WOODMEN HILLS METROPOLITAN DISTRICT REGIONAL WATER RECLAMATION FACILITY

EROSION CONTROL NOTES

Markup Summary

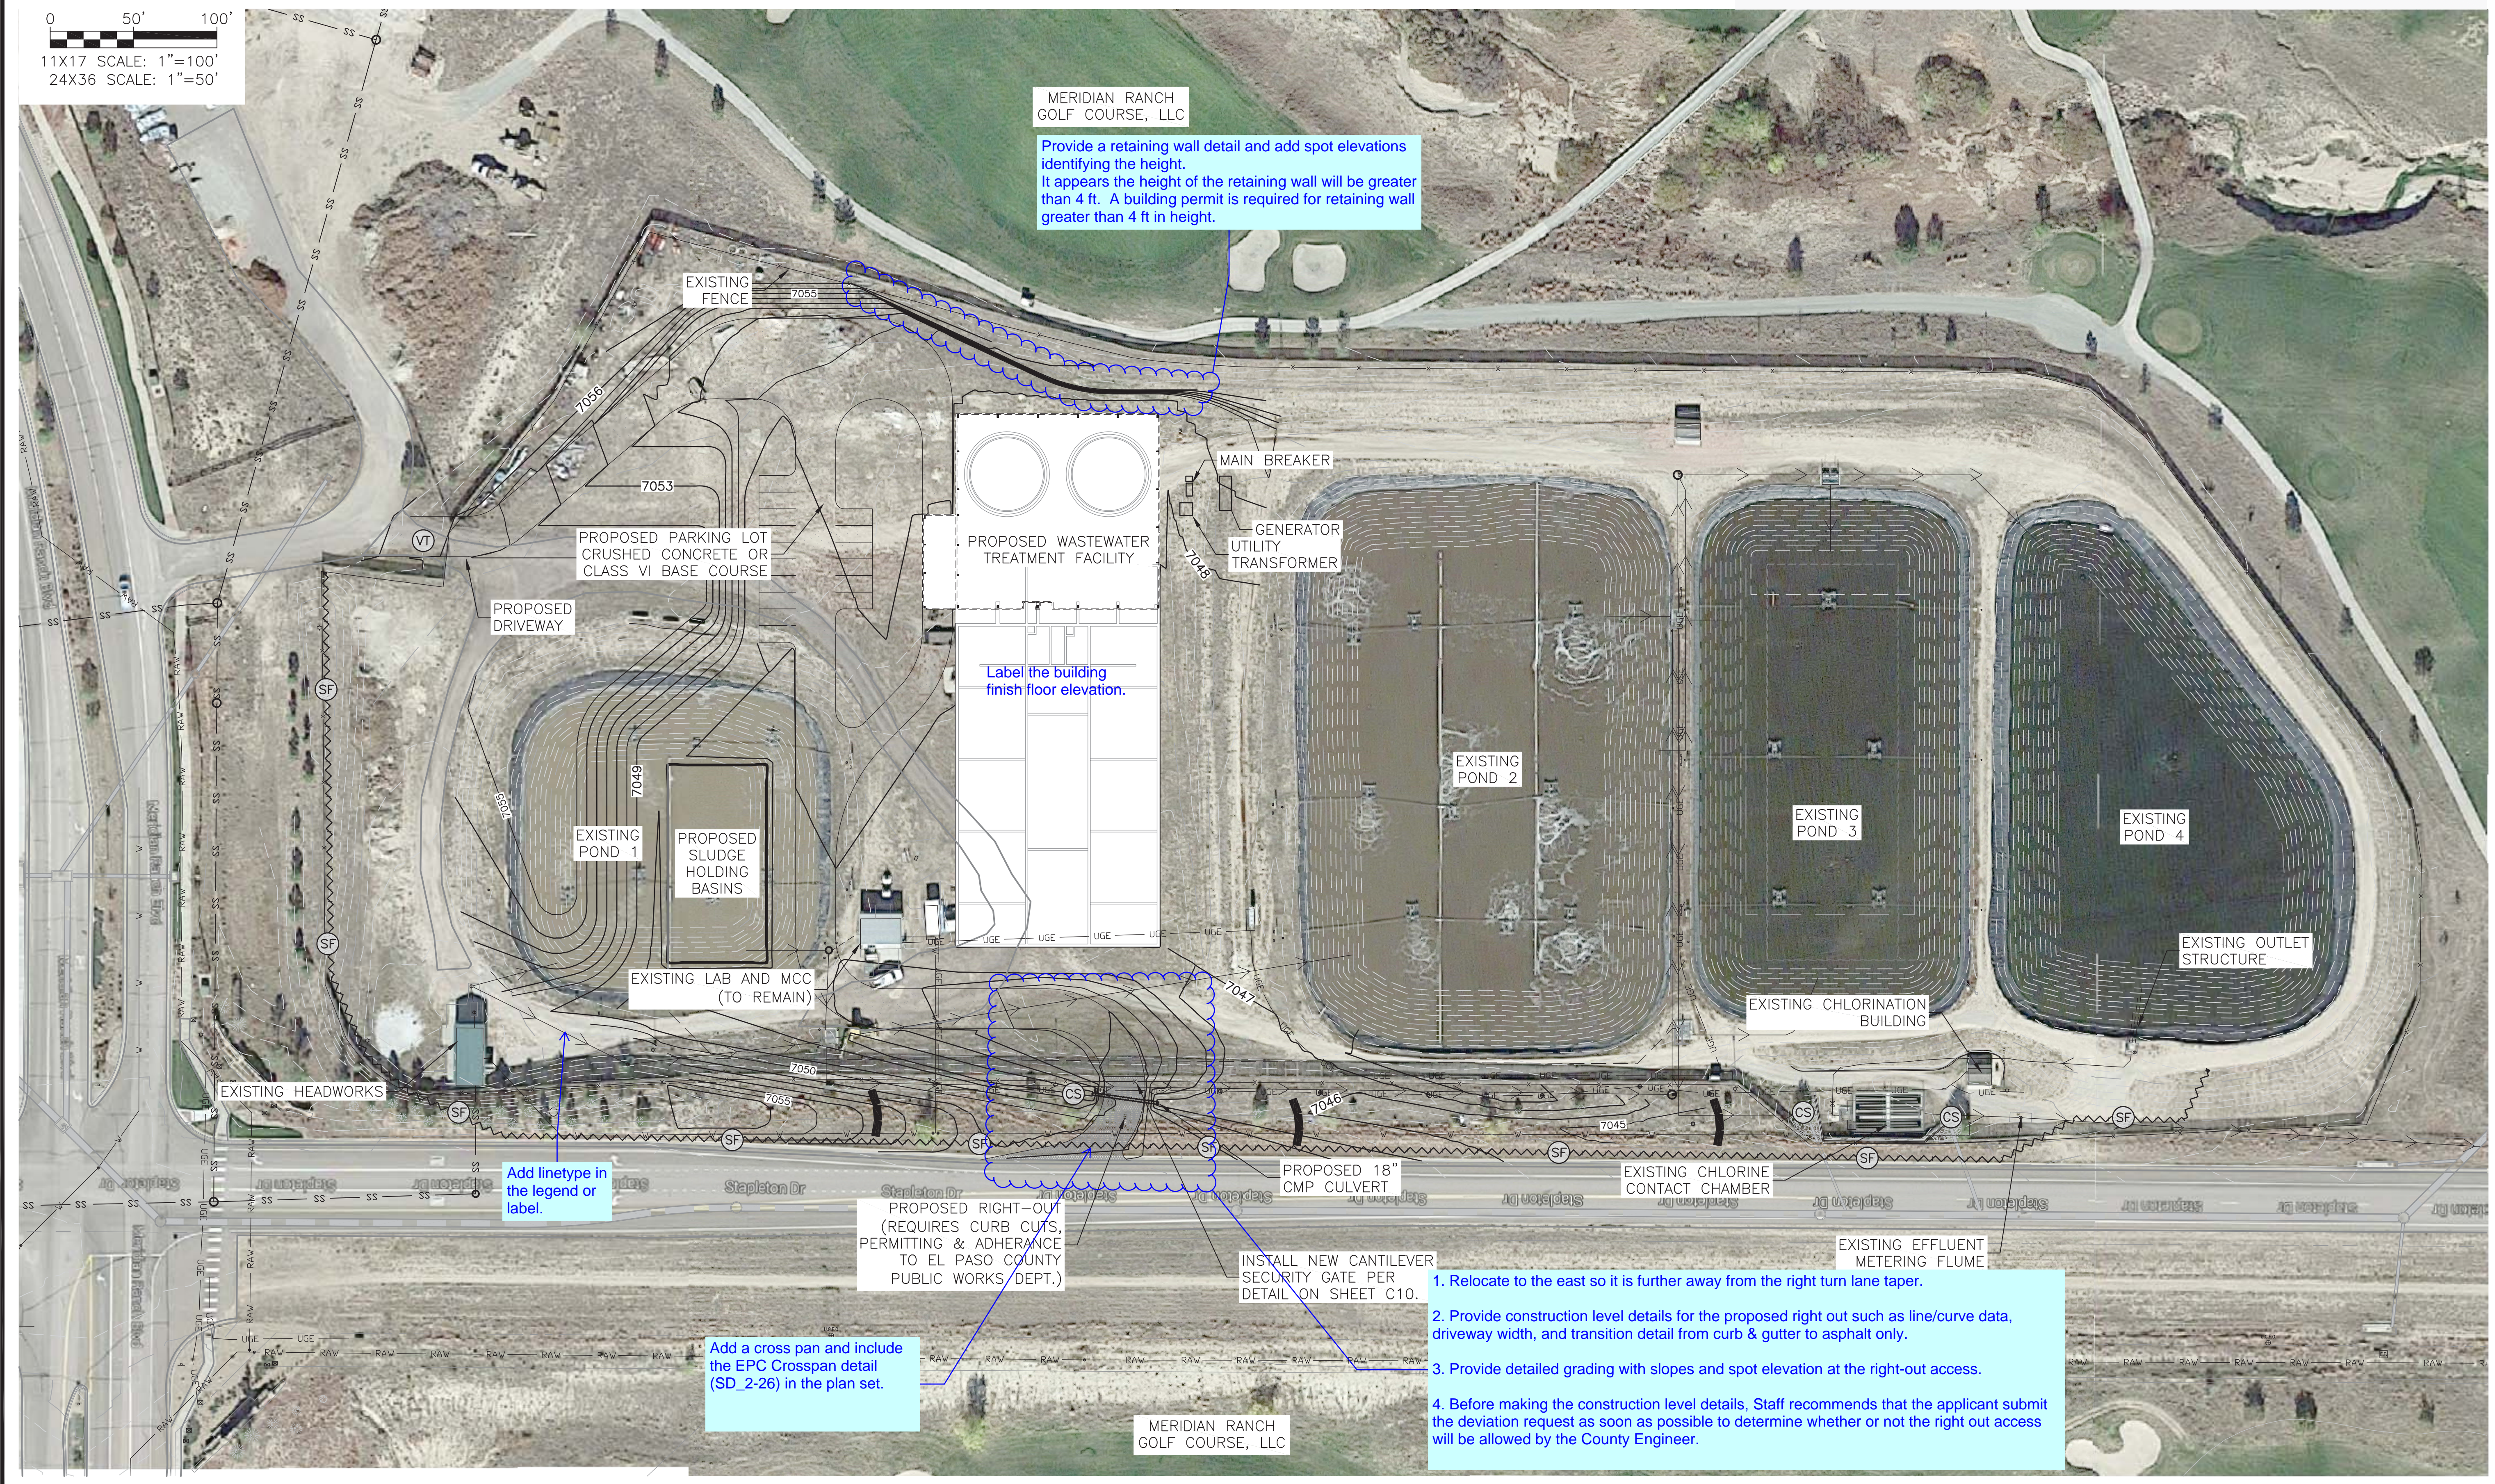
Show staging area and stockpile area.

MERIDIAN RANCH GOLF COURSE, LLC
 Provide a retaining wall detail and add spot elevations identifying the height. It appears the height of the retaining wall will be greater than 4 ft. A building permit is required for retaining wall greater than 4 ft in height.

Label the building finish floor elevation.

Add linetype in the legend or label.

Add a cross pan and include the EPC Crosspan detail (SD_2-26) in the plan set.

1. Relocate to the east so it is further away from the right turn lane taper.
2. Provide construction level details for the proposed right out such as line/curve data, driveway width, and transition detail from curb & gutter to asphalt only.
3. Provide detailed grading with slopes and spot elevation at the right-out access.
4. Before making the construction level details, Staff recommends that the applicant submit the deviation request as soon as possible to determine whether or not the right out access will be allowed by the County Engineer.
